J. Bernie Beasley, Jr., P.E.
Vice President
Vogtle Project

**VOGTLE ELECTRIC GENERATING PLANT (VEGP) RESPONSE TO REQUEST
FOR ADDITIONAL INFORMATION CONCERNING GL 96-06, ASSURANCE OF
EQUIPMENT OPERABILITY AND CONTAINMENT INTEGRITY DURING
DESIGN-BASIS ACCIDENT CONDITIONS**

Response to GL 96-06 RAI

SOUTHERN COMPANY SERVICES, INC. BIRMINGHAM, ALABAMA		
GEORGIA POWER COMPANY ALVIN W. VOGTLE NUCLEAR PLANT		
SIMPLIFIED DIAGRAM NUCLEAR SERVICE COOLING WATER SYSTEM - UNIT 1 TRAIN A REF: REA 98-VAA085 / GL 96-06 RAI		
SCALE:	DRAWING NO.	REV
JOB NO. 10604	SHEET 1 OF 3

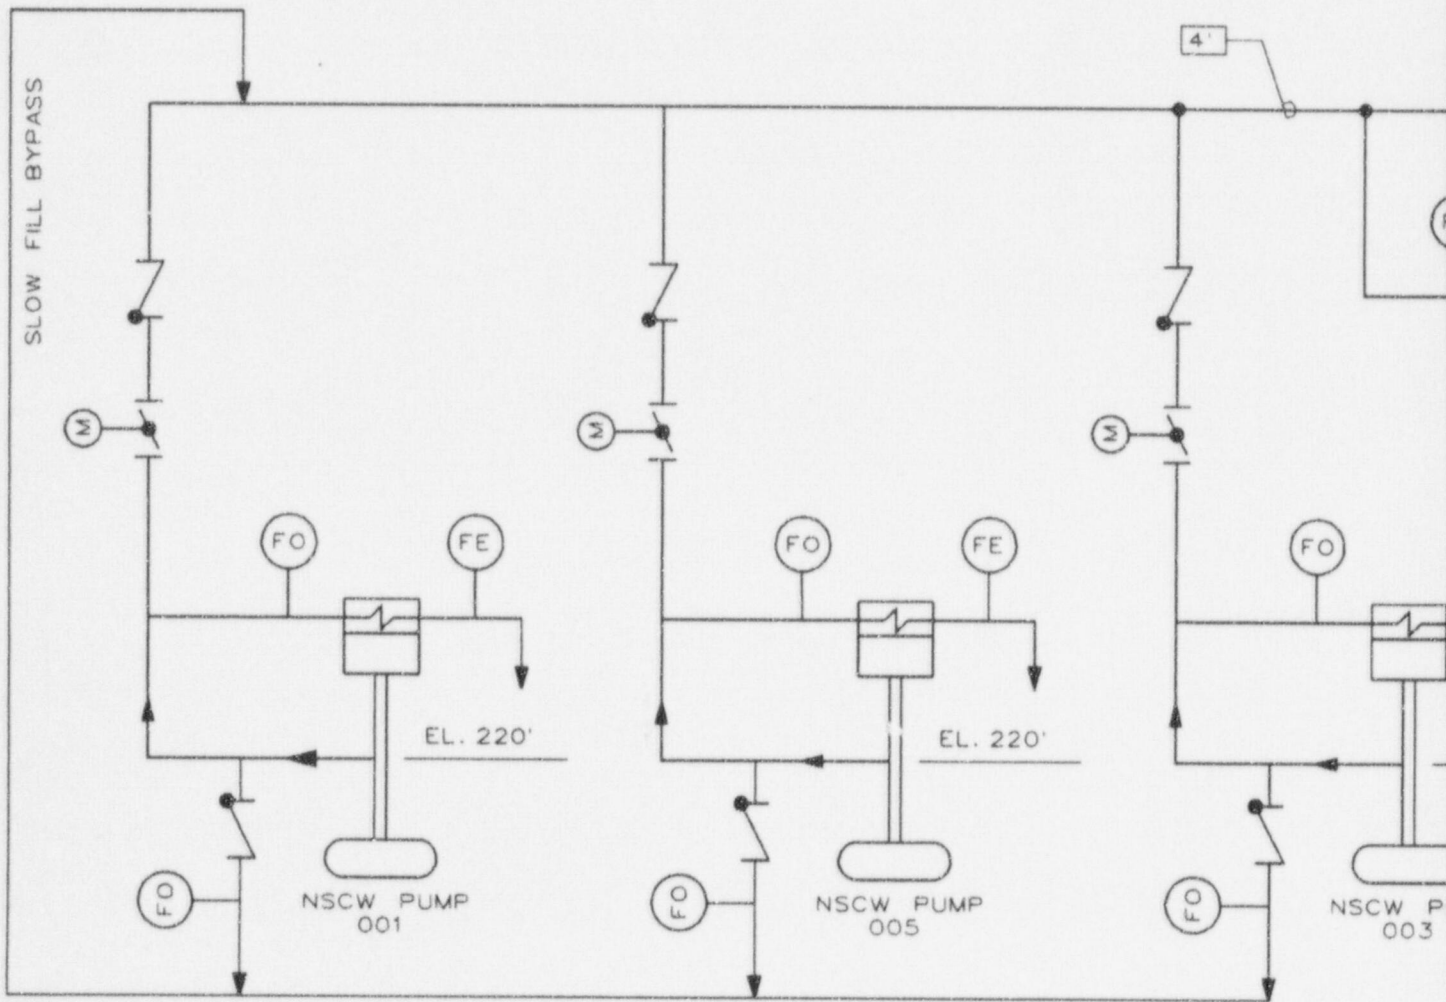
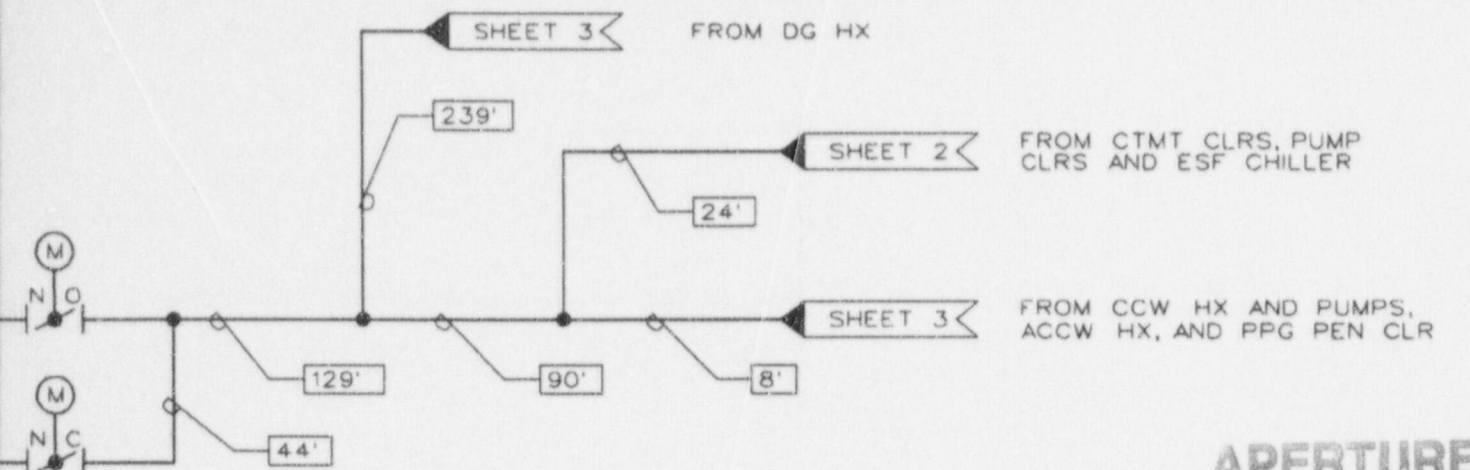
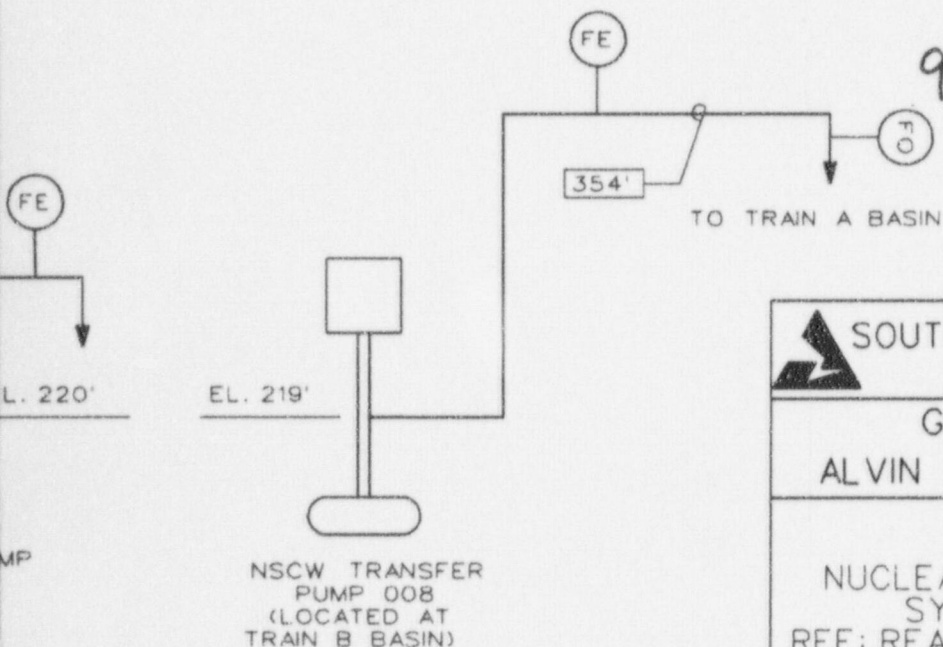
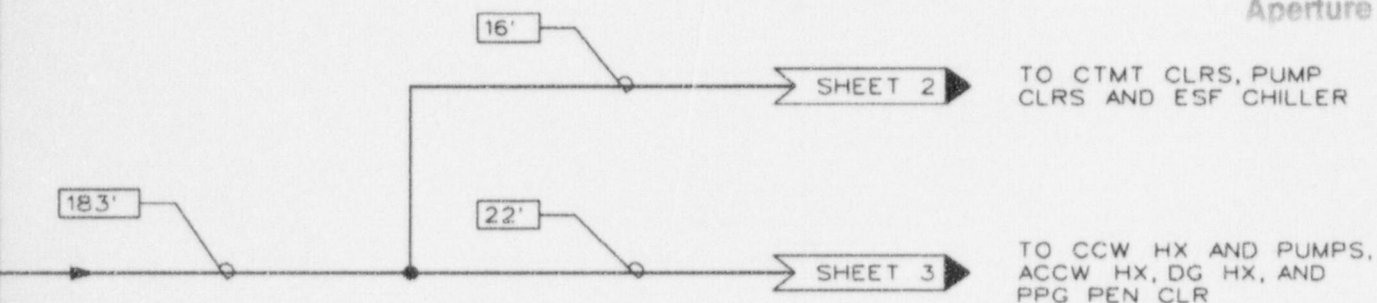
Provide a simplified diagram of the affected system, showing major components, active components, relative elevations, lengths of piping runs, and the location of any orifices and flow restrictions.

A simplified diagram of the Unit 1, train A NSCW system is attached. There is close similarity between all trains/units of the VEGP NSCW system, although there are some differences. As can be seen by review of the NSCW P&IDs, differences include the use of manual valves for throttling in the vicinity of the CCW and ACCW heat exchangers, the location/use of certain orifices, and the configuration of branch locations. The simplified diagram provides approximate lengths of the major piping runs between the indicated junction/interface points. The diagram also provides approximate elevations of major equipment. Unless otherwise indicated, the elevations shown represent the elevation of the piping at the inlet connection to the equipment. Please note that a partial system isometric sketch was previously provided with the VEGP response to GL 96-06.
